**Pennsylvania Power & Light Company**

**SUSQUEHANNA STEAM ELECTRIC STATION  
RESPONSE TO 10/28/93 RAI ON SPENT  
FUEL POOL COOLING SYSTEM  
PLA-4944 FILE # RA1-35415**

**PP&L RESPONSE TO  
NRC REQUEST FOR ADDITIONAL INFORMATION  
ON THE  
EFFECTS OF A LOSS OF SPENT FUEL POOL COOLING  
FOLLOWING A LOSS OF COOLANT ACCIDENT  
SUSQUEHANNA STEAM ELECTRIC STATION UNITS 1 AND 2  
DOCKET NOS. 50-387 AND 50-388**

Typical Lineup of  
RHR Fuel Pool Assist

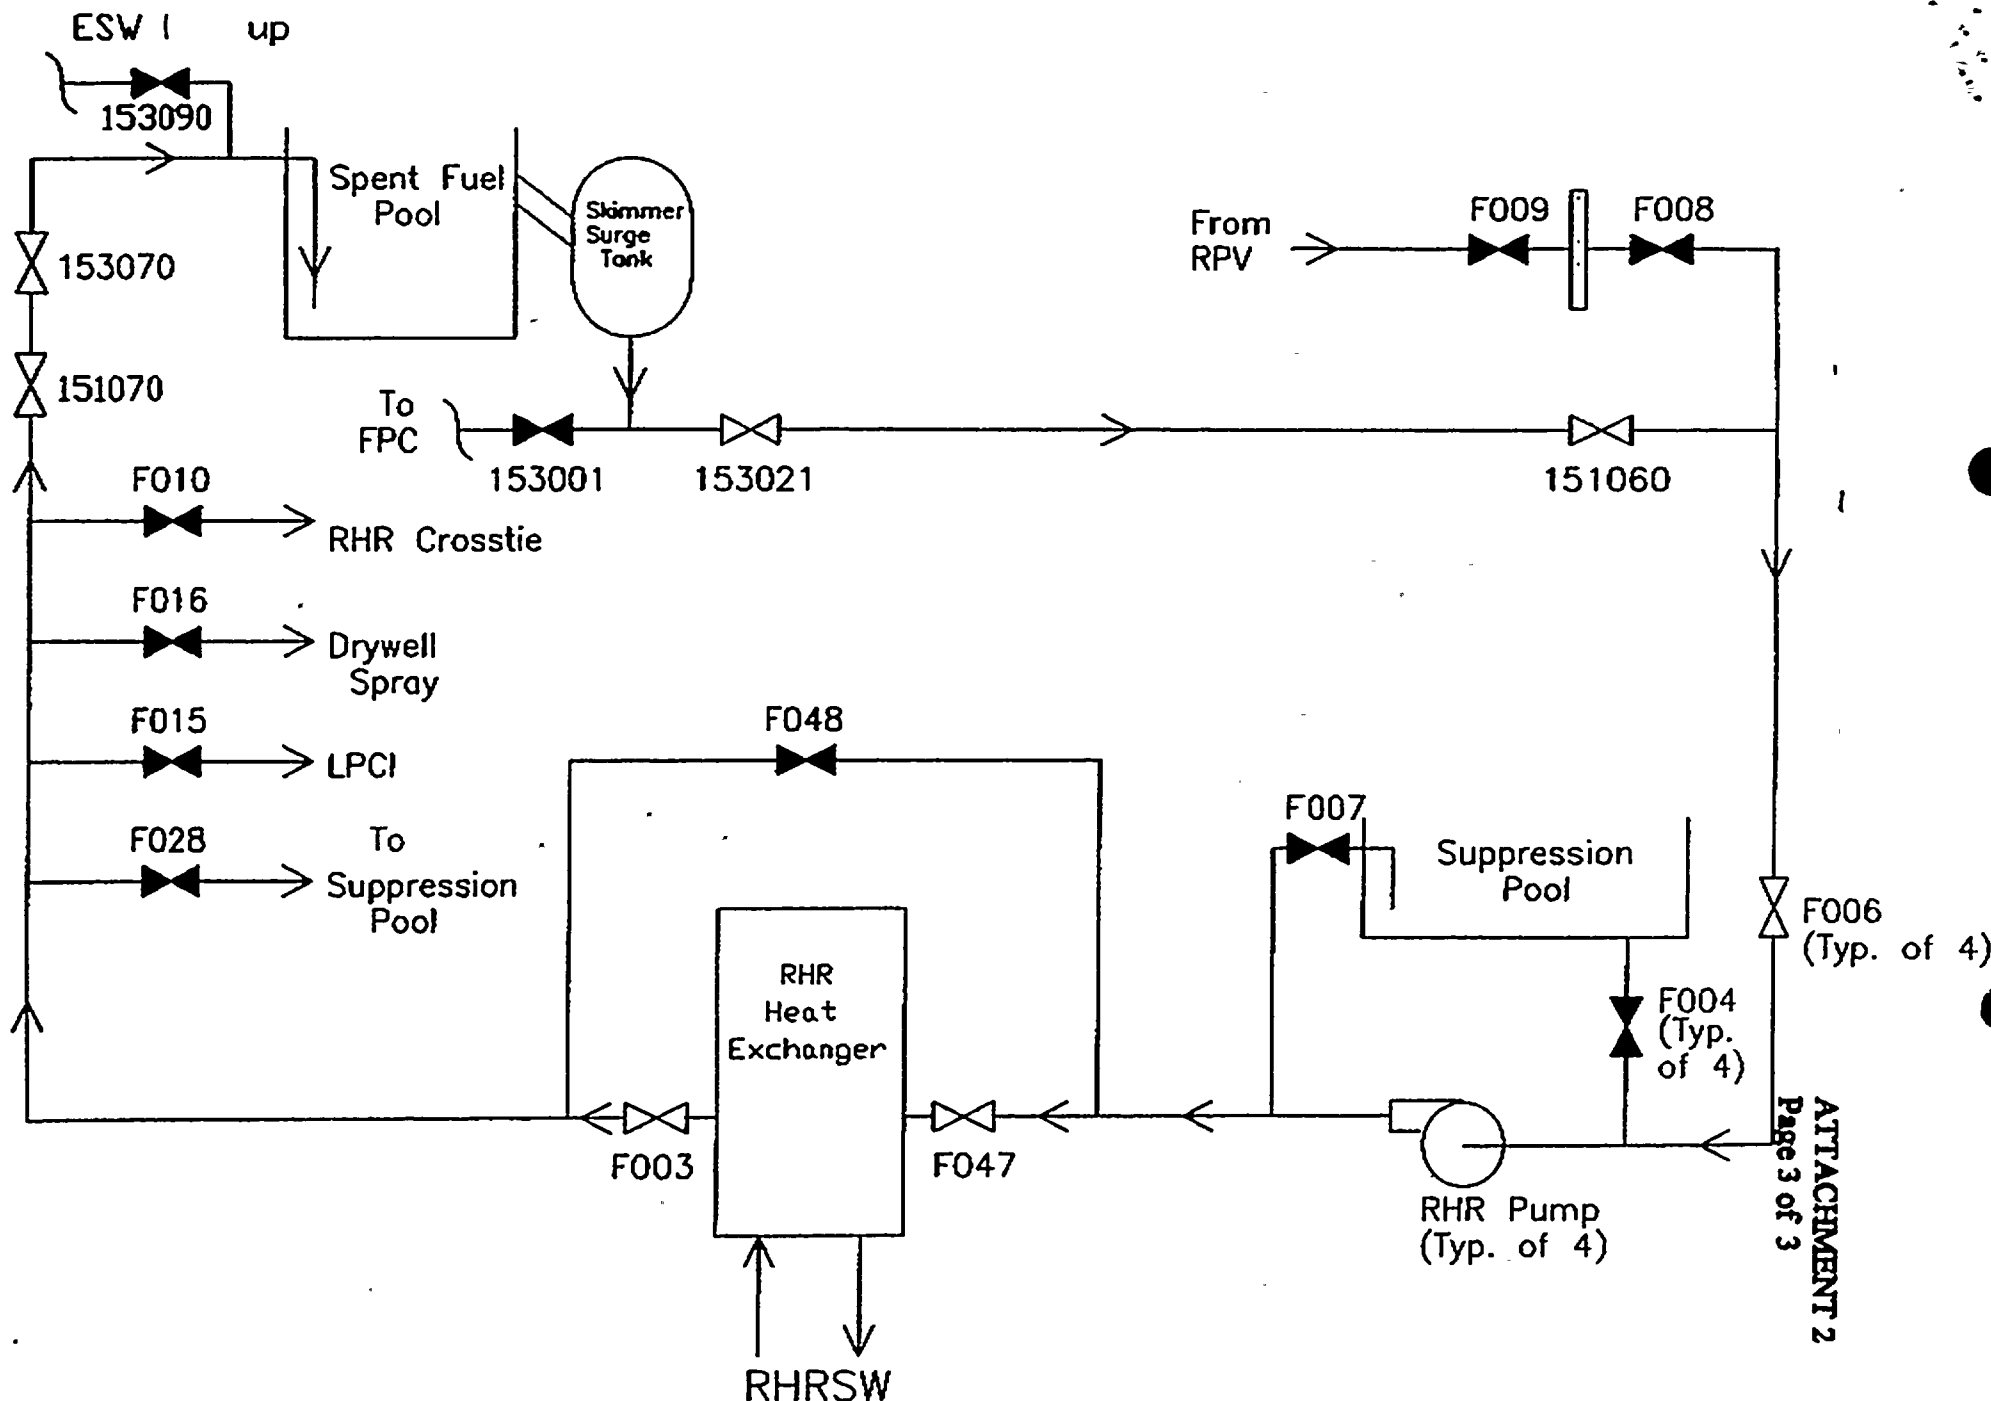
2. With regard to the use of RHR in the SFP cooling mode, provide:
  - a) A description of the pre-operational tests including system lineups and initial conditions.
  - b) Copies of the relevant pre-operational test data sheets showing results for the RHR Fuel Pool Cooling mode.

Typical preoperational test, lineup is as follows, in accordance with OP-49/249-003, (ref. attached diagram)

- RHR minimum flow valve (F007) interlock is defeated to prevent inadvertent dumping of Fuel Pool water into the Suppression Pool
- Fuel Pool (FP) Skimmer Surge Tank to Fuel Pool Pump valve, 153001 is closed
- FP Skimmer Surge Tank to RHR valve, 153021 is opened
- FP to RHR valve 151060 is opened
- The 2 normal RHR Suppression Pool suction valves (F004), for the loop to be used, are closed

- The appropriate RHR Shutdown Cooling suction valve (F006), for the pump to be used, is opened
- RHR to Fuel Pool valve 151070 is opened
- RHR Heat Exchanger valves, F003, F048 are open and after pump is started, the F048 will be throttled for desired cooling
- RHR Heat Exchanger inlet valve (F047) is closed
- Ensure adequate Fuel Pool level (makeup via condensate transfer or Emergency Service Water (ESW))
- Check system filled and vented
- Start pump and throttle flow between 1500 - 6000 gpm as desired (1500 gpm is needed for min flow pump protection)
